RE: Professional Consulting Services – Noise Study Review and Comment - The 850 Project, Town of Kingston, NY.

Barton & Loguidice, D.P.C. (B&L) is pleased to review and provide technical comments concerning the Noise Evaluation prepared by Maser Consulting, dated March 9, 2021 concerning the 850 Project in the Town of Kingston, NY.

PROJECTED NOISE LEVELS

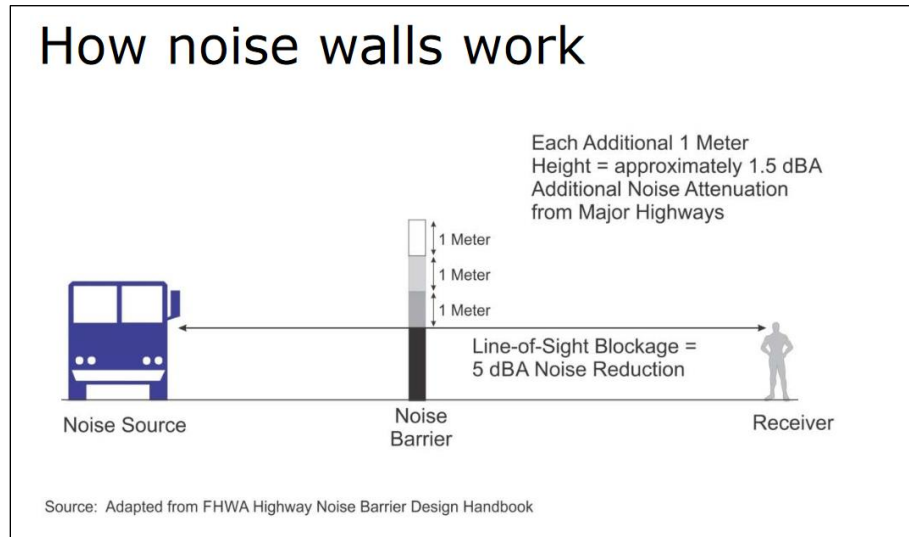
3. The study provides a representative noise level for Receptors 1 through 7. Table C-1 for Receptor 1 (attached) summarizes the construction noise levels of the rock drilling and harvesting process. However, the decibel level of the Blast Hole Drill Rig is stated as 84 dBA in contrast to the NYSDEC Table, included later on in the study, which identifies this source as 98 dBA. The Front End Loader noise source and the Dump Truck noise source from Table C-1, are for machines much smaller than what would be utilized in a rock blasting, loading, and transporting to the crusher function. Blasted hard rock, such as the rock on site, would not be expected to be loaded into a typical road worthy Tri-Axle dump truck until after processing. The machinery needed to handle the blasted rock include a “Euclid” type off-road dump truck (90 dBA) such as the type already observed to be on-site and a loader similar to the Hitachi 501 (92 dBA) as shown in the table below from page 268 of Maser Noise Study, March 9, 2021.

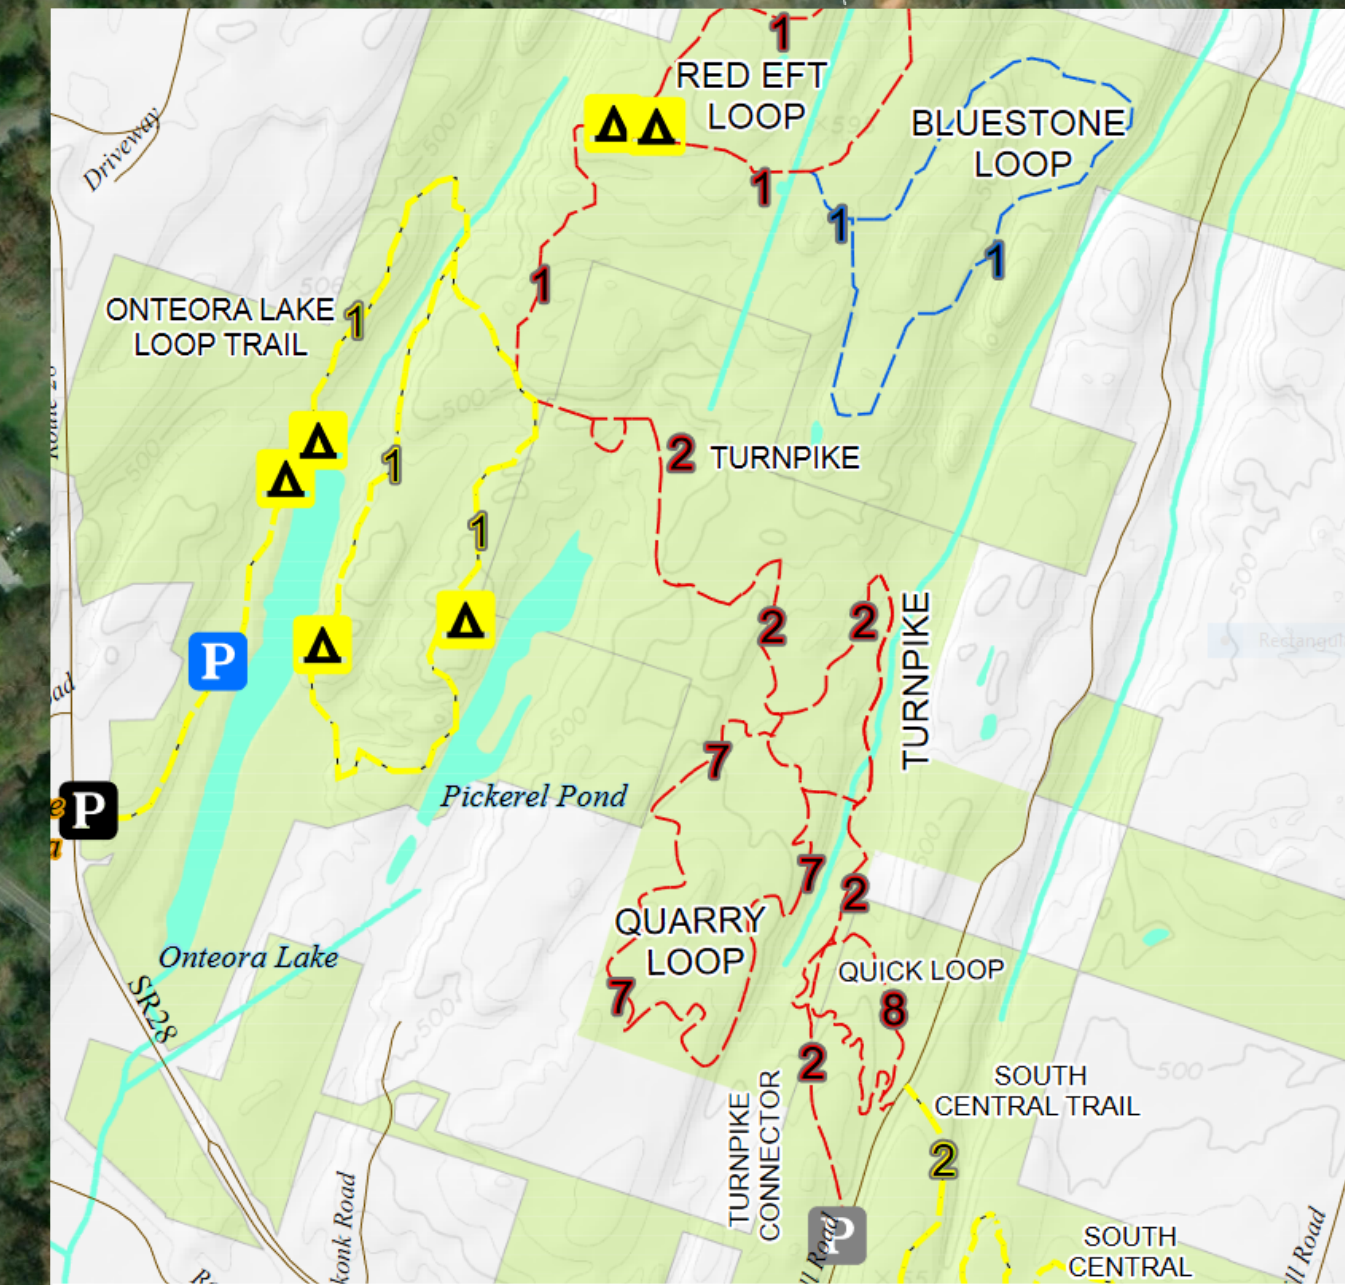
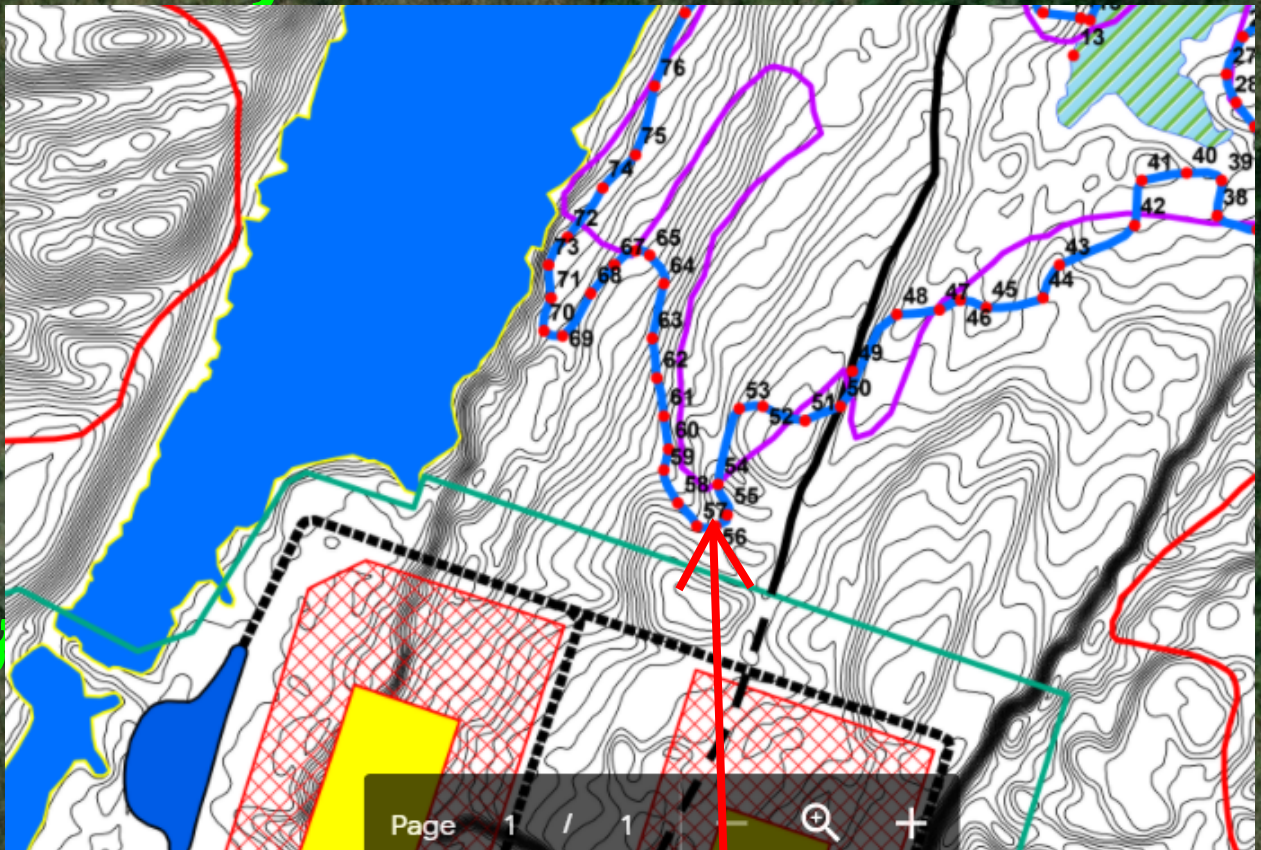
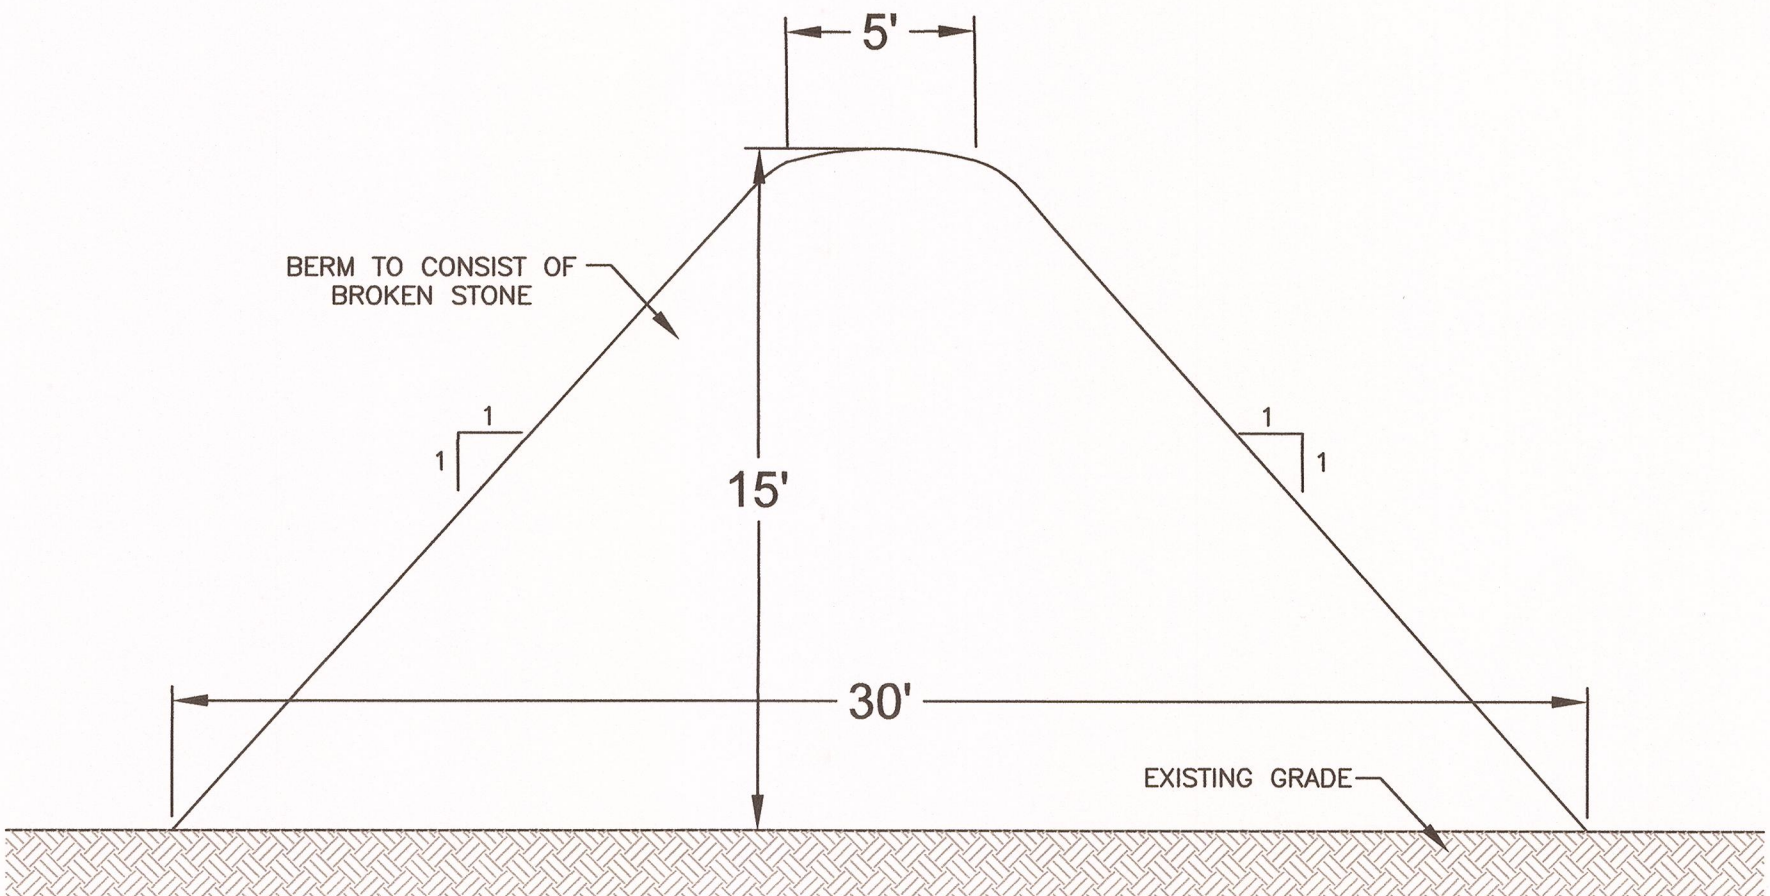
Continuing with Receptor R1, the noise level calculated for Receptor 1 assumed all the equipment would be operating at a distance of 800' away. This is not the case by any means. B&L Figure 1, provides examples of when the rock drilling and loading will take place approximately 150' from Receptor 1 and at a few other sample locations using the minimal information provided by the various maps, drawings with different scales and north-south orientations, missing contours, etc. and other submission materials. Applying the appropriate noise source levels as discussed above, and accounting for when the work is close to sensitive areas, not 800' away, the noise levels at locations along the trail will be more than 35 to 40 decibels higher than existing levels after accounting for minimal vegetative attenuation. An over 20 dBA increase is intolerable according to the NYSDEC Policy.

Rock Drill, Loader, and likely Two (2) Euclid's will be everywhere in the Red Shaded Area Conducting Drilling, blasting, loading and moving, dumping. Bulldozer in the western end to spread stone for 10' fills not in study

T = BUILD = 90 dBA at 150' from work area
Q = BUILD = 72 dBA at 800' (includes 5 dBA of Tree and Vegetation Attenuation)
R = BUILD = 72 DBA includes 6 dBA of Vegetative Attenuation
S = 79 dBA on Trail at 600'

SOUND BARRIER
PLAN
FOR
850 ROUTE 28 LLC
TOWN OF KINGSTON
ULSTER COUNTY NEW YORK

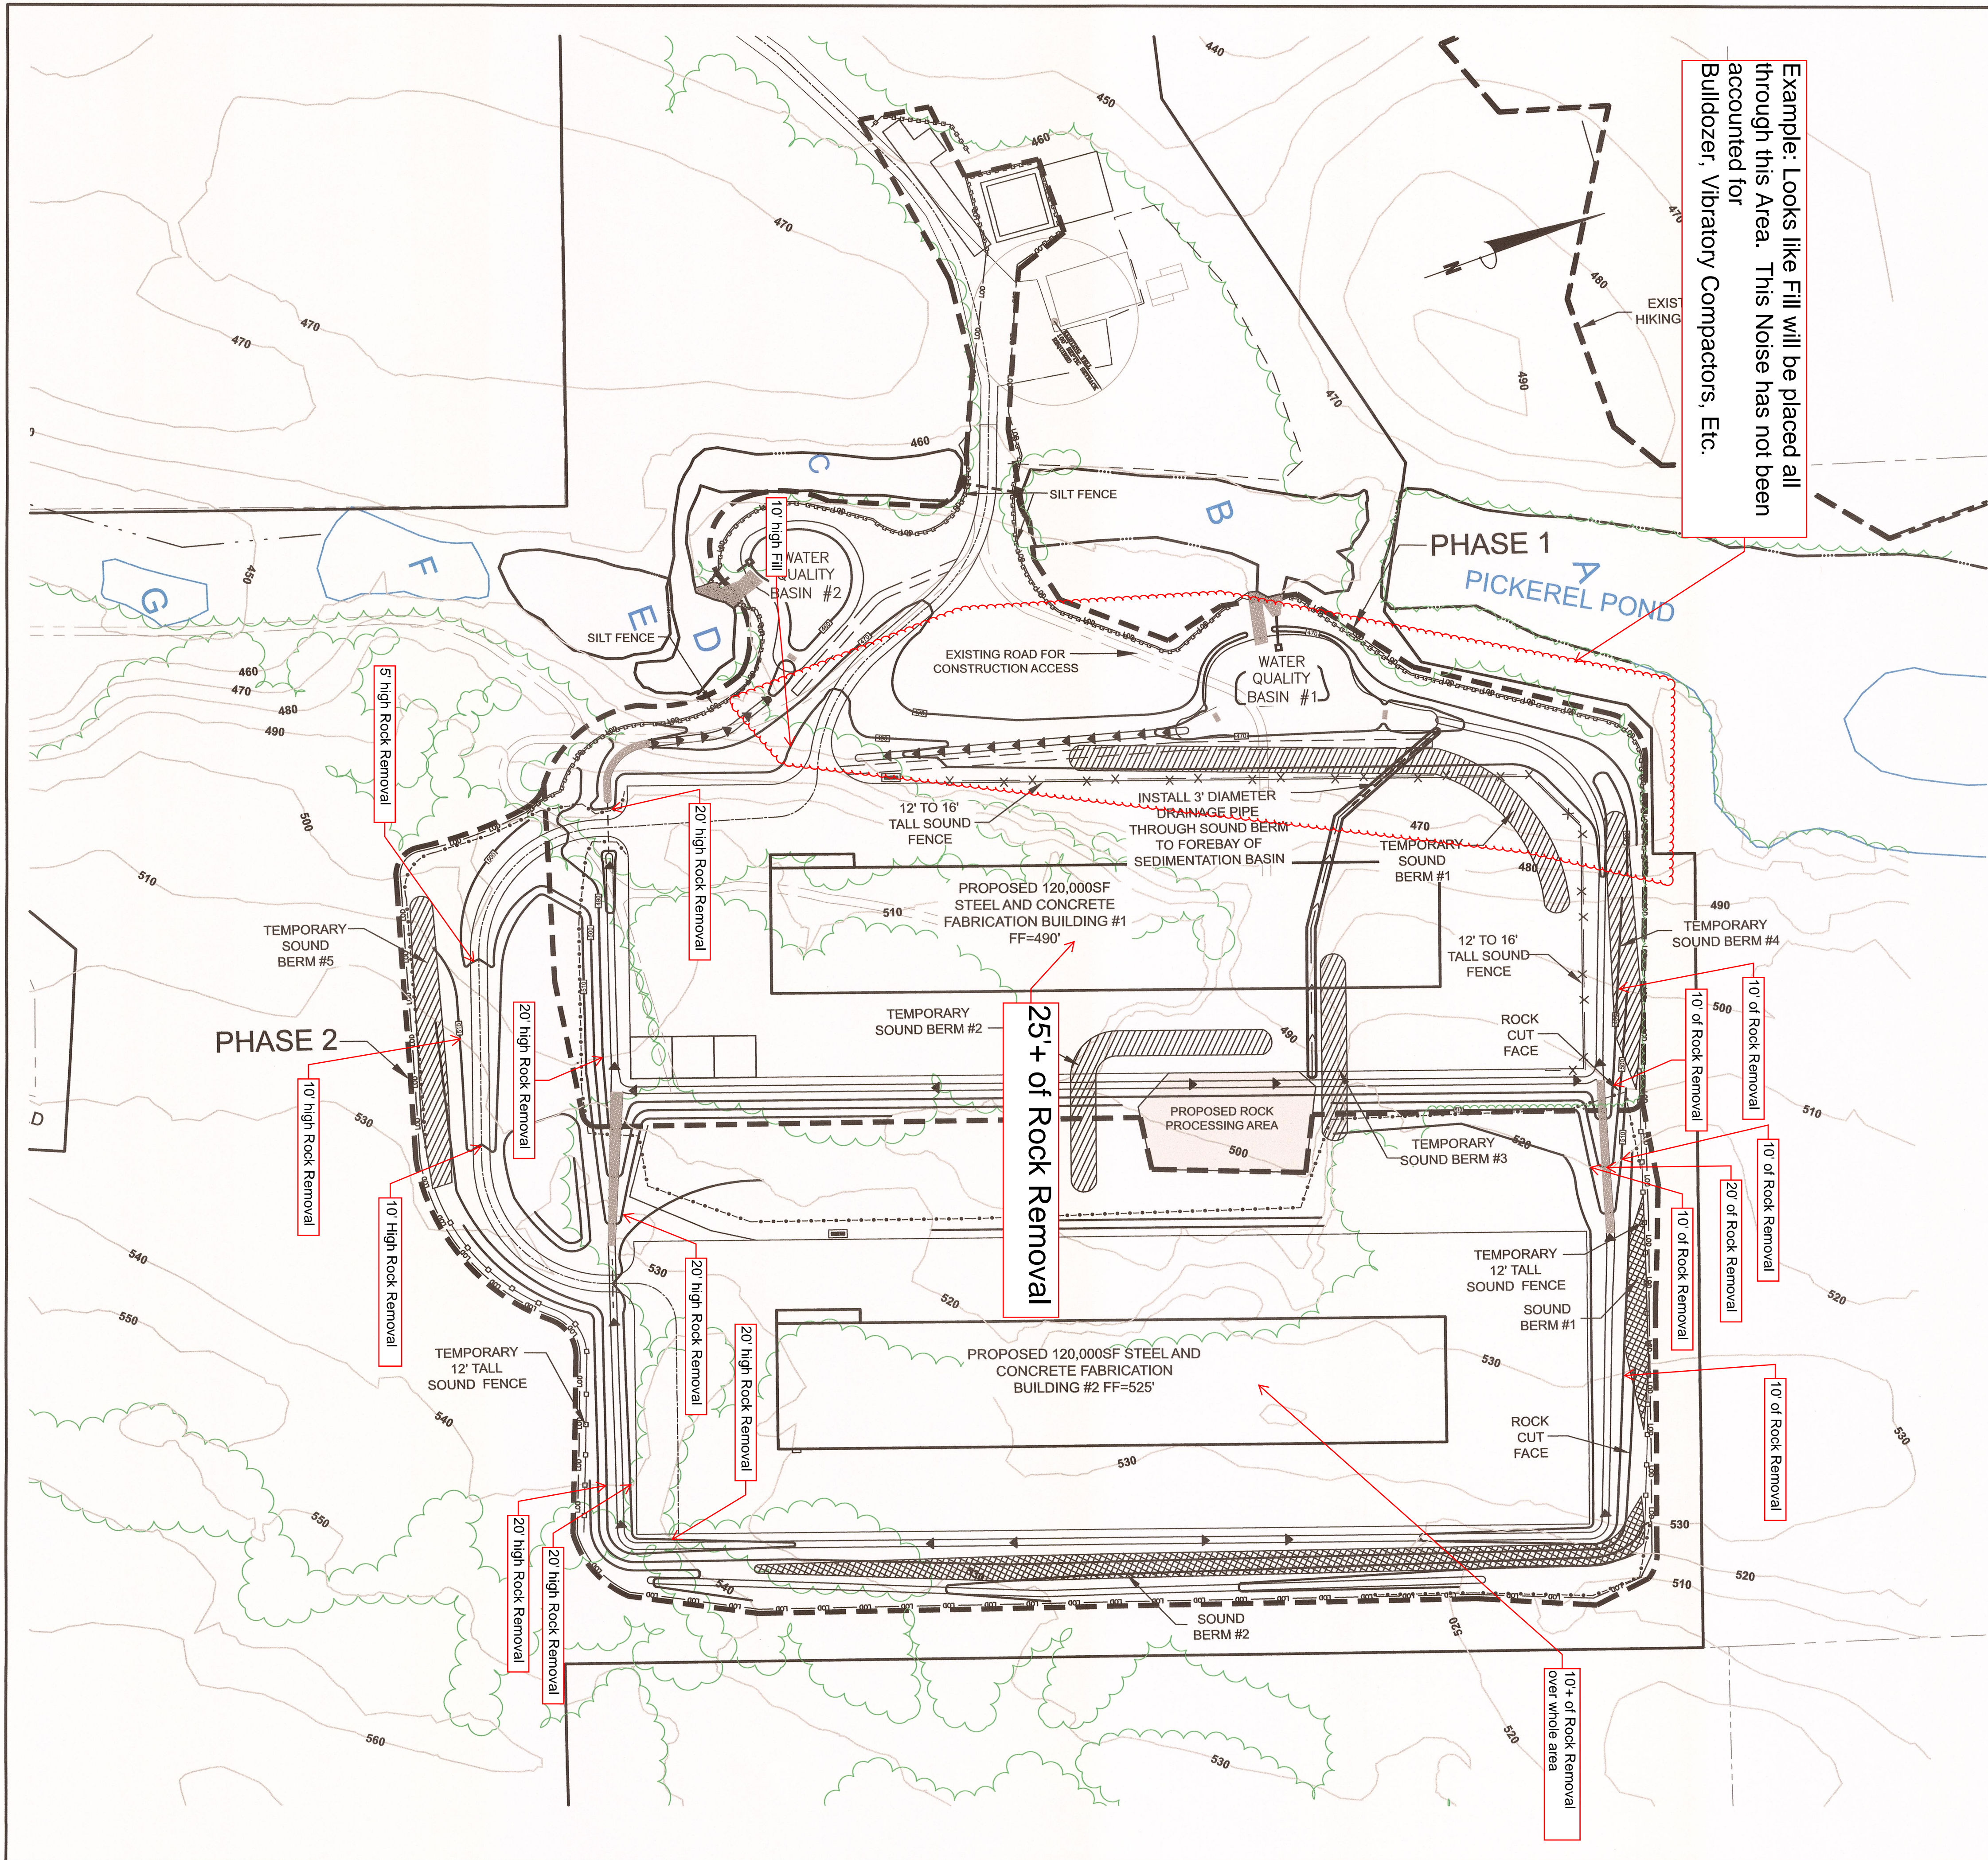
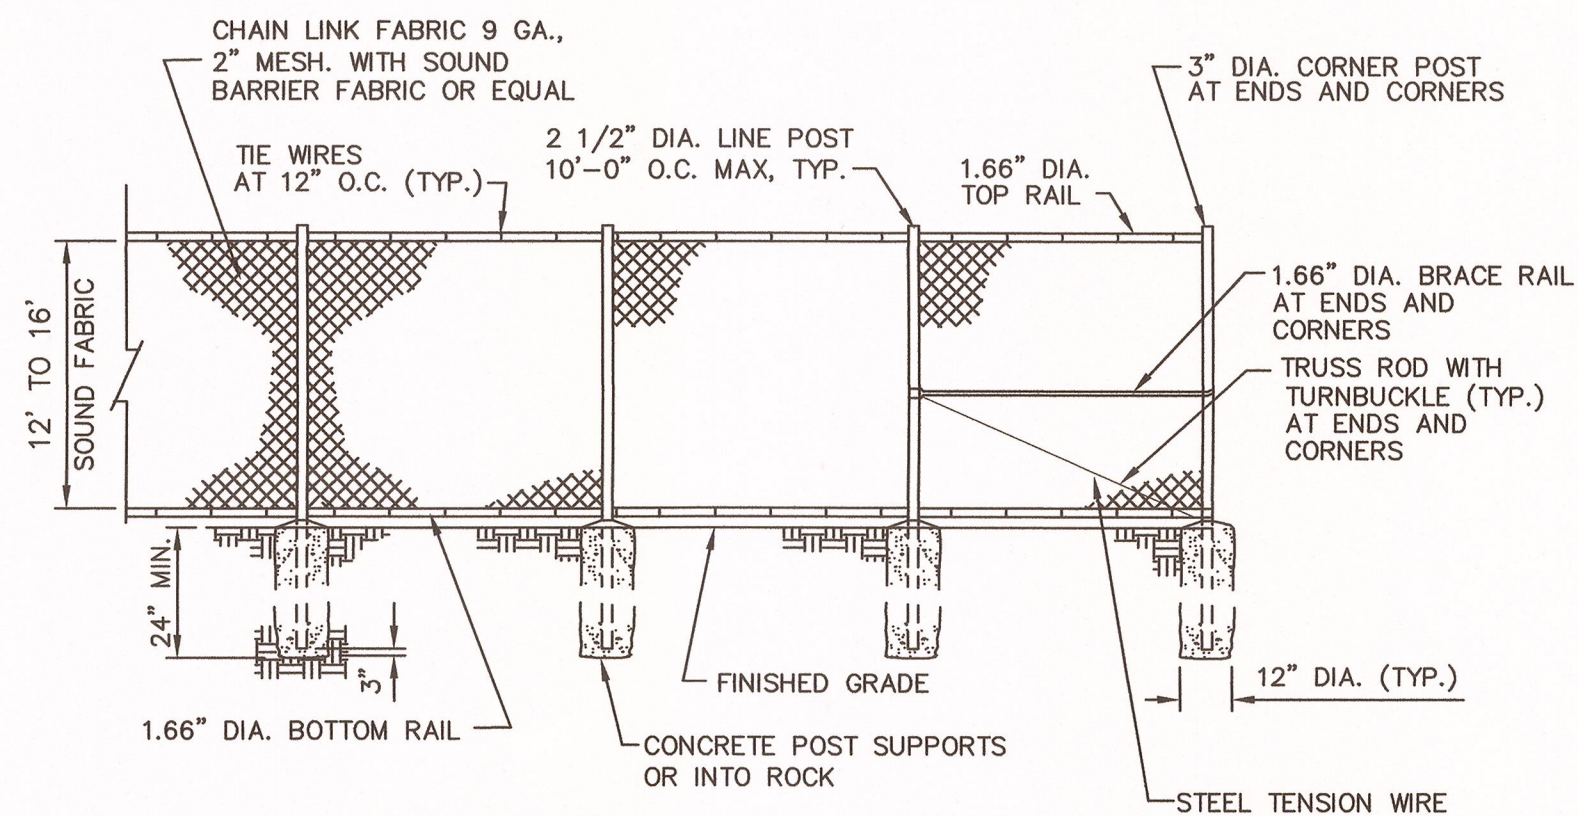
6. Noise berm attenuation in the study is assigned a 15 dBA reduction where the study quotes information from a Federal Highway Administration (FHWA) document called the *Audible Landscape* which was published in 1974. While correctly stated in the study that a barrier can reduce noise as much as 15 dBA, it does not mean that all barriers provide that level of performance. What is omitted from that discussion is that for a barrier to be effective, it first needs to cut-off the line of sight from the source to the receptor to provide 5 dBA of attenuation. Additional attenuation, as described in a more recent FHWA guidance (Highway Noise Barrier Design Handbook - February 2000), states that a barrier can provide up to 1.5 dBA of attenuation for every 1.0 meters (3.2') of additional height. Therefore, once the barrier is high enough to cut off the line of sight of the noise source from the location it is proposing to

shield, it must be more than twenty-one (21') higher than that initial cut-off height to provide a 15 dBA reduction. Using the data provided in the various noise studies to date, it is apparent that this type of berm attenuation is not being proposed. The berms proposed in the study are only 15' in height, the terrain differences and the various noise source locations in relation to the berms have not been adequately considered. Note that the engine fans, engine, and exhaust system are the primary noise sources on the heavy equipment to be used and they are at least 6' tall to start with.

9. The proposed sound fence is shown to include concrete bases for the posts. The Applicant seems to be committing to install concrete footings or rock coring every 10' feet for the sound fence. While this may be the case for the permanent fence, it is not likely going to occur for the temporary locations. Any gaps along the bottom of the fence will need to be sealed off to prevent transmission of noise under the fence for the temporary and permanent installations. Installing temporary sound fence over uneven rocky terrain is very difficult and will be challenging to seal off the pole bases to prevent noise leakage.

The sound fence shown on the Sound Barrier Plan proposes to use a proprietary product described as Acoustifence. The 1/8" thick material proposed has a Sound Transmission Class of 28 decibels (STC 28). This does not mean it will reduce the noise levels by 28 dBA. The testing used to determine the STC ratings is from the 1960s and does not include the lower frequencies of human hearing in the ratings, which just happens to be where the majority of the construction noise produced on the site will be (125 Hz and lower).
